Provincial Approving Officer's Comments

The following comments are based upon information received by the Ministry up to August 2, 2011.

Savary Island Trail Map

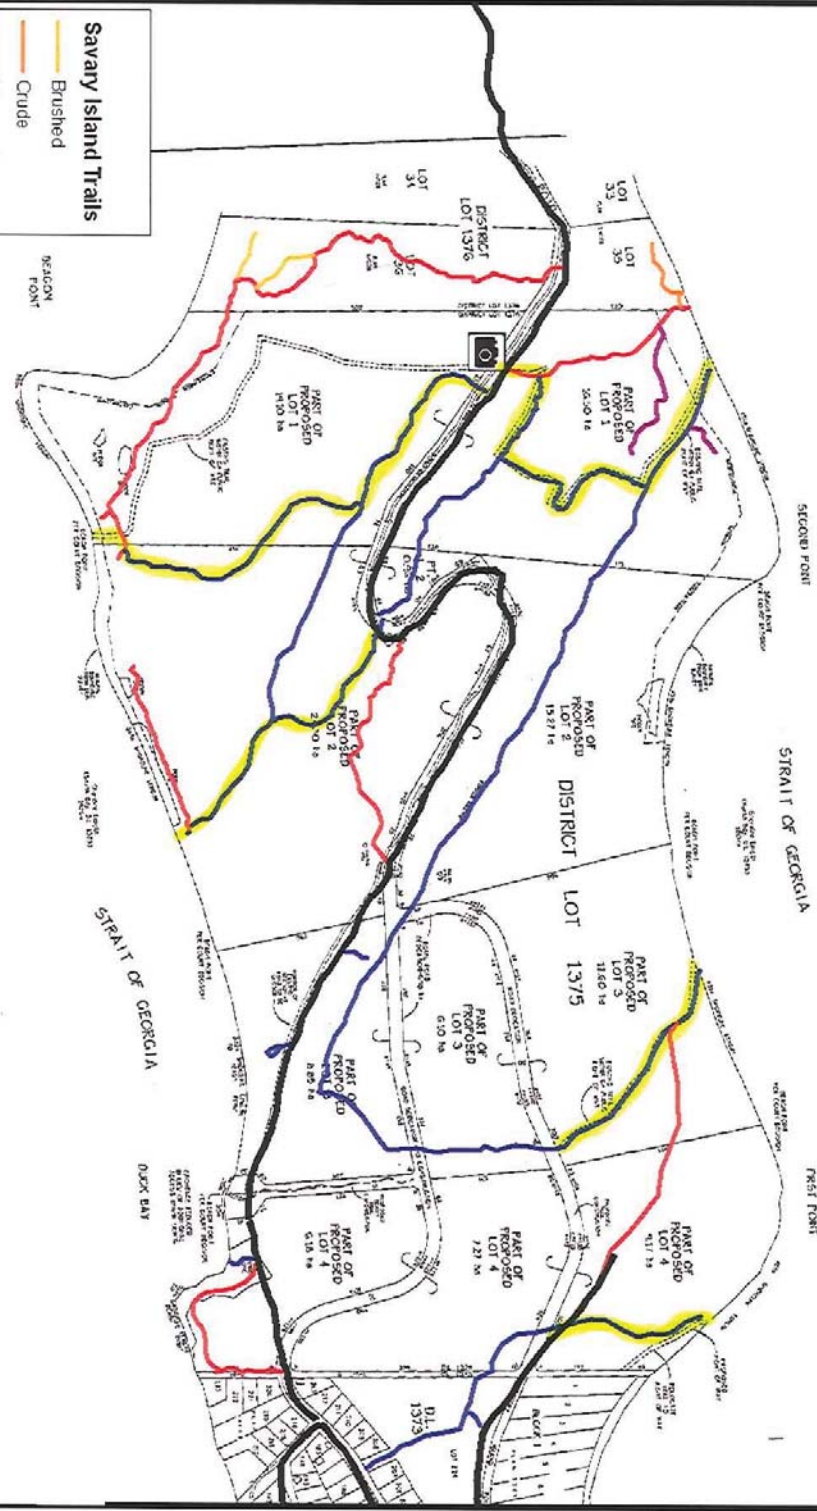
- 4) The trails highlighted on the attached map shall be protected by a 6.0 meter wide statutory right-of-way pursuant to Section 218 of the *Land Title Act*. At the foreshore, the right-of-way shall be expanded to create an area 20.0 meters wide. The Powell River Regional District requires that a development permit be completed for the trail system and may require that additional trails to those identified on the map be included as part of the trail system. Any additional trails identified during the development permit process must also be covered by a statutory right-of-way. A copy of the development permit shall be submitted to this office. The Minister of Transportation and Infrastructure and the Powell River Regional District shall be included as parties and all documents and plans necessary to implement the statutory rights-of-way must accompany the final subdivision plans.
